UNITED STATES PATENT AND TRADEMARK OFFICE

| APPLICATION NO. | FILING DATE | FIRST NAMED INVENTOR | ATTORNEY DOCKET NO. | CONFIRMATION NO. |
|--|-------------|----------------------|---------------------|------------------|
| 10/700,801 | 11/03/2003 | Alfred Geissler | 0250-130 | 6267 |

Office Action Summary

DETAILED ACTION

Additionally, the swivel head 3 has a "cylindrical hollow housing member" coaxial with axis 5 that is rotatable within a neck in the "head support" 1. See the partial reproduction of Figure 3 below.

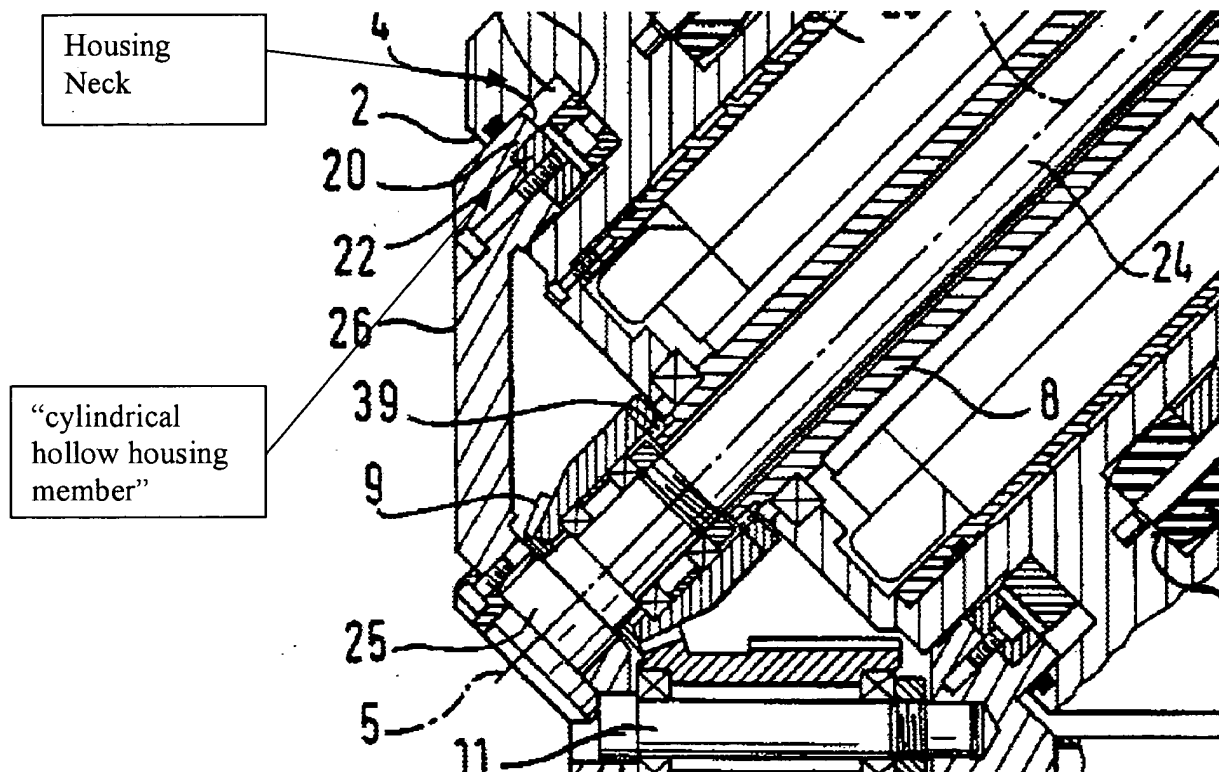
8. Claims 1 and 3, as best understood, are rejected under 35 U.S.C. 102(b) as being anticipated by U.S. Pat. No. 5,533,846 to Geissler.

Geissler teaches a universal milling and drilling machine (see title of invention) that includes a “head support” 1 movable in “several” coordinate axes (see Figure 1, movable in at least the vertical direction via vertical guides 105 and the direction extending into the plane of the paper via guide rails 103). The support has a front face 2 and an axis of rotation 5 “pointing forward and downward by 45°” (see Figures 1-3 and col. 3, lines 32-45, for example). A swivel head 3 is arranged on the front face 2 (see Figures 1-3). A “spindle nose” (where the spindle 6 is located) is fixedly attached to the swivel head 3 (see Figures 2-3). Note that the axis of rotation of the spindle 6 is arranged at an angle of 45 degrees with respect to the swivel axis 5 (see col. 3, lines 40-45 and Figures 1-3).

“Spindle motor” 7 is mounted in the “head support” 1 (Figure 3), and is “aligned coaxially” with respect to swivel axis 5 (see Figure 3 and col. 3, lines 46-48). Motor 7 “has” a shaft 24. At least ultimately “on” the end of shaft 24 that protrudes from “head support” 1, a bevel gear 9 is “arranged” (see Figure 3, see also col. 4, lines 58-60 and col. 5, lines 7-10). Shaft 24 is used to rotate the swivel head 3 about the axis 5 (see Figure 3 and col. 4-5).
